## CONTRACT CHANGE ORDER NO. 35

PROJECT NAME Evergreen Road Bridge Replacement Project SHEET 1 OF 2

CCO #35  
SHEET 2 of 2

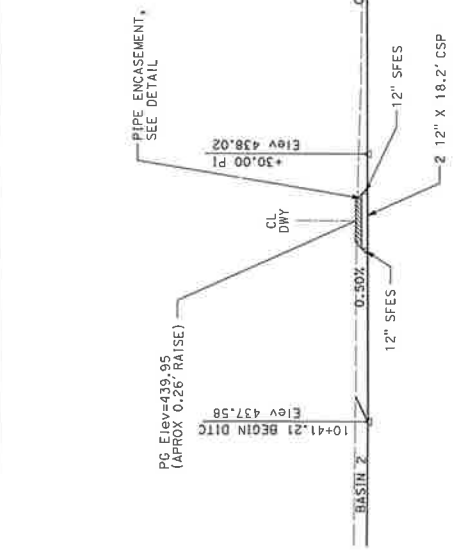
In accordance with Section 4-1.05, Changes and Extra Work, of the Standard Specifications, perform the following work. As directed by the engineer, construct a new drainage system and drainage ditch to provide an overflow outlet for the constructed retention basin, as shown on Sheet C-13. Excavate swale to restore natural run-off into the newly constructed roadside ditches.

Excavate swale within the County Right-of-Way to restore flow of natural run-off into the newly constructed roadside ditches.

Construct a new drainage system and drainage ditch. The lump sum price will constitute full and complete compensation, including all labor, materials, equipment, and incidentals to complete the work.

TIE INTO DITCH 12  
AT STA 32+50  
Exist LOW-HEAD PVC
